**MCDOWELL COUNTY SCHOOLS  
MCDOWELL COUNTY, WEST VIRGINIA  
FALL RIVER ELEMENTARY WINDOW AND DOOR REPLACEMENT & MOUNT VIEW  
HIGH RESTROOM RENOVATIONS  
ADDENDUM #3  
December 2, 2021  
THRASHER PROJECT #060-10246**

P2.01R1

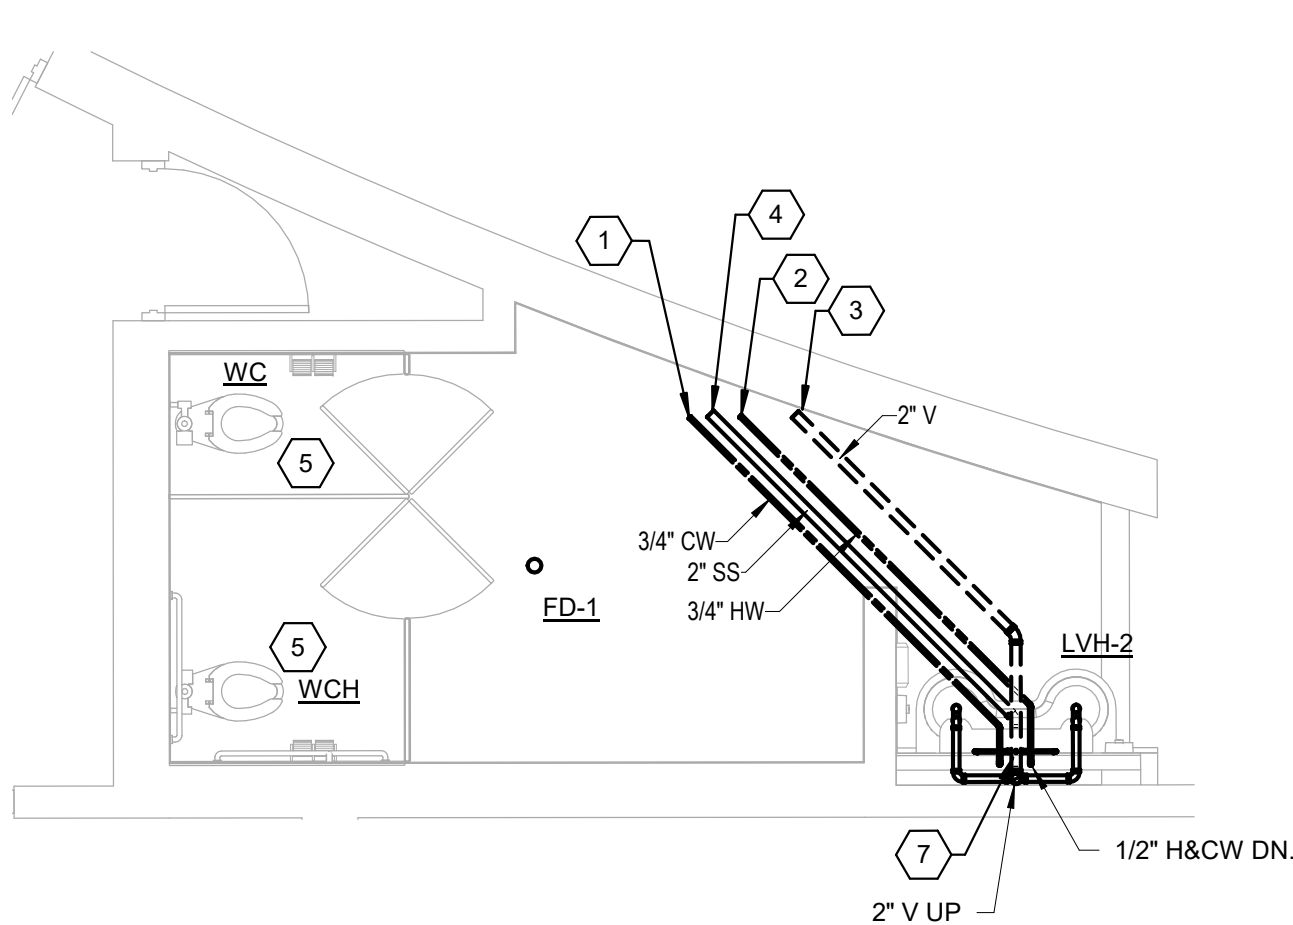
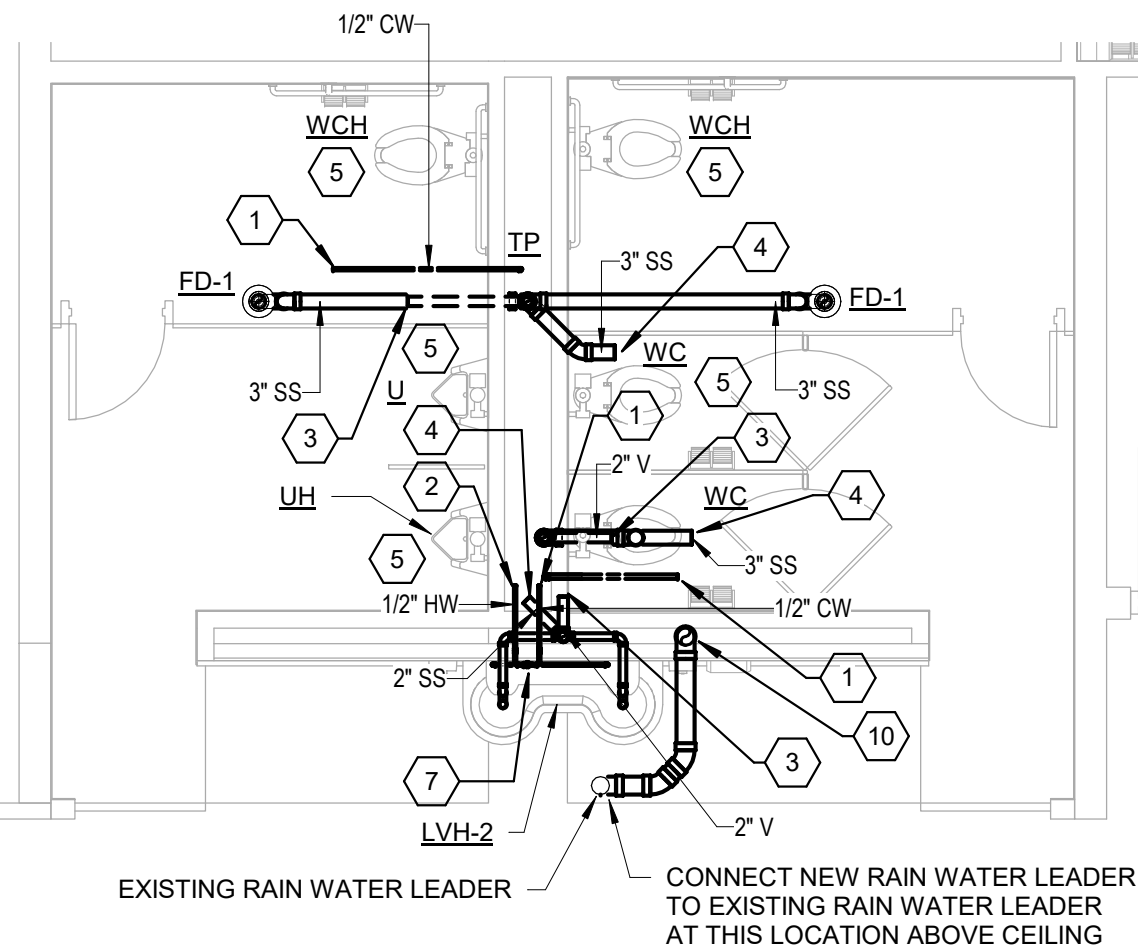
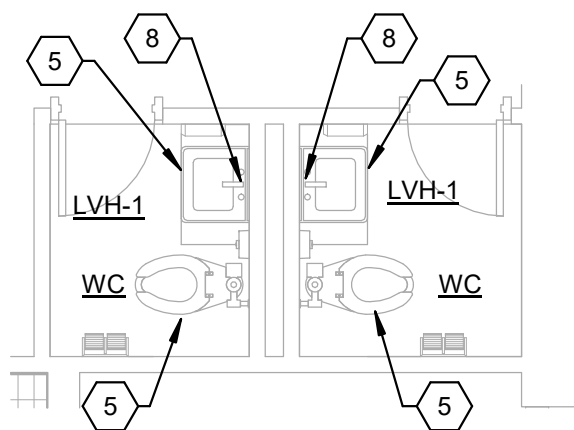
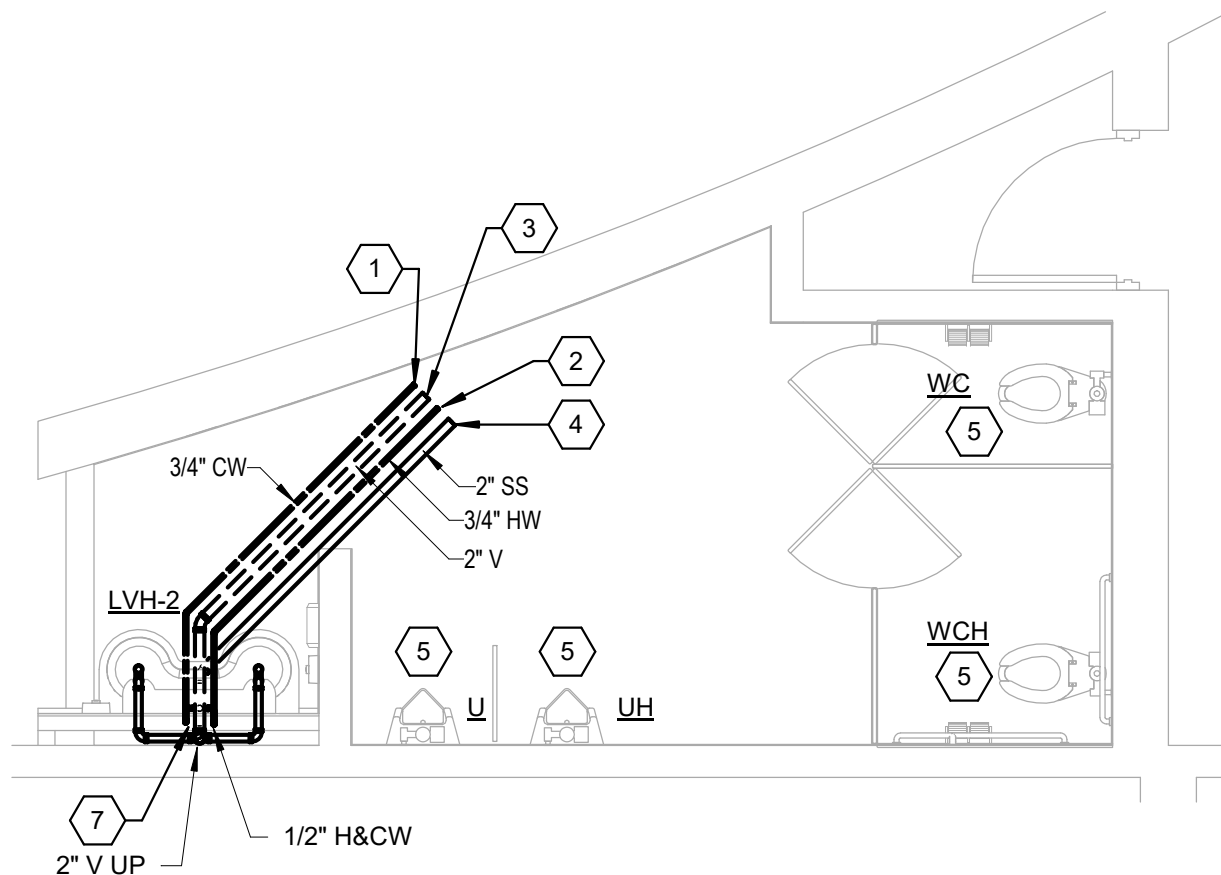
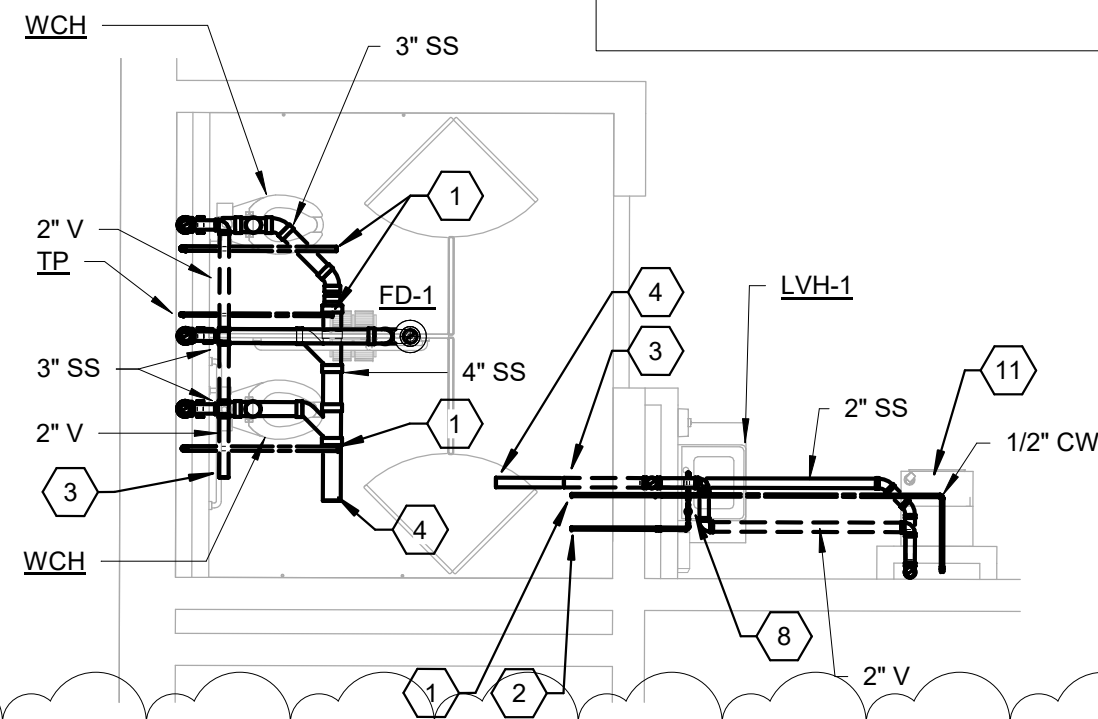
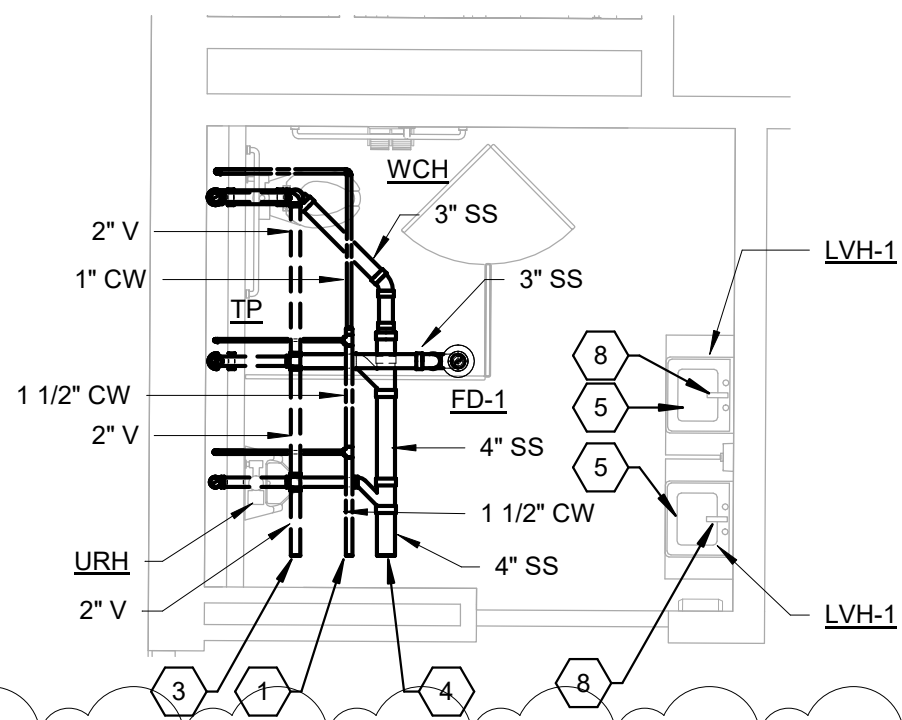
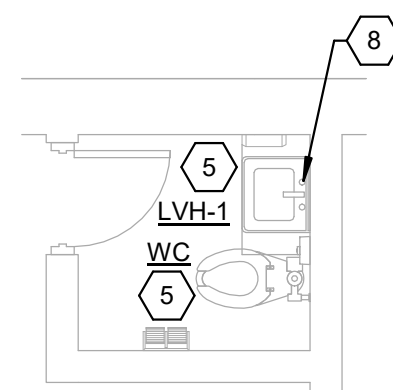
**50.** No floor drain in restrooms 209 & 210. Is this correct?

Floor drains have been added. See revised drawing P2.01.
